Product / Process Change Notification (PCN)		
☒ Major Change ☐ Minor Change		
PCN Number: PCN_FeSTAR-Series_20250101 Affected Series: WE-STAR-Series Affected Order Codes: see tables below PCN Date: 2024-10-01 (YYYY-MM-DD) Effective Date: 2025-01-01 (YYYY-MM-DD)	Change Category: ☐ Equipment/Location ☒ General Data ☐ Material ☐ Process ☐ Product Design ☐ Shipping/Packaging ☒ Supplier ☐ Software	
Contact: Product Management Phone: +49 (0) 7942 - 945 5001 Fax: +49 (0) 7942 - 945 5179 E-Mail: pcn.eisos@we-online.com	Datasheet Change: ☒ Yes ☐ No Attachment: ☒ Yes ☐ No	
Description of change: For the purpose of a datasheet information enlargement and internal standardization, Würth Elektronik will implement a new measurement setup to improve the accuracy and extend the comparability of values. Additionally, the operating temperature range will be enlarged. This is a measurement method and datasheet visualization change only. There will be no change in form, fit, function, quality of the product. A support note is attached describing the background of the change.

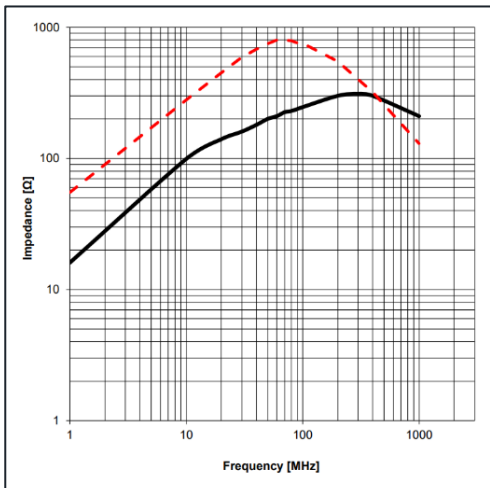
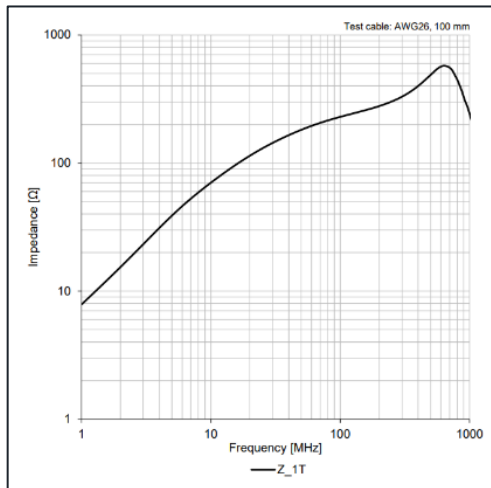
3. The visualization of chart for the **“Typical Impedance Characteristics”** changes. The used type of cable and cable length is shown in each chart.

Before change:	After change:
Showing only one graph with 1 turn (1T) and 2 turns (2T) impedance curves. 	Showing a graph for the 1 turn (Z_1T) impedance curve with the shortest possible cable length according to the product.

- Showing no graph with 3 turns impedance curve.

- Showing a graph for 1-3 turns (Z_{1T} , Z_{2T} , Z_{3T}) impedance curves with the shortest possible cable length, which is required for 3 turns according to the product.

WE-STAR-RING Series:

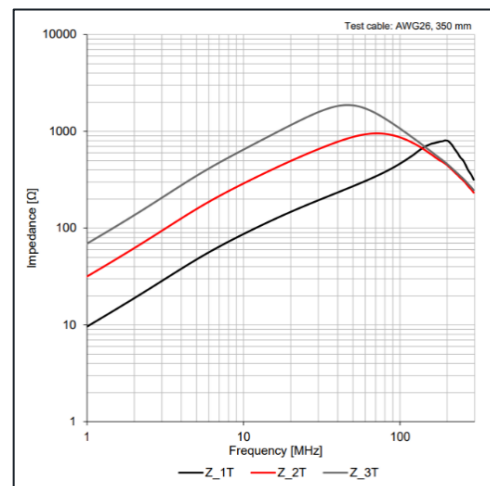
Part Number Impedance @	Before change:		After change:		
	25 MHz 1turn	100 MHz 1turn	25 MHz 1turn	100 MHz 1turn	short cable length
7427151	64	119	60	123	100 mm
7427151S	64	119	60	123	100 mm
7427153	83	165	75	149	100 mm
7427153S	83	165	75	149	100 mm
7427154	71	130	68	132	100 mm
7427154S	71	130	68	132	100 mm
7427155	55	110	54	112	100 mm
7427155S	55	110	54	112	100 mm
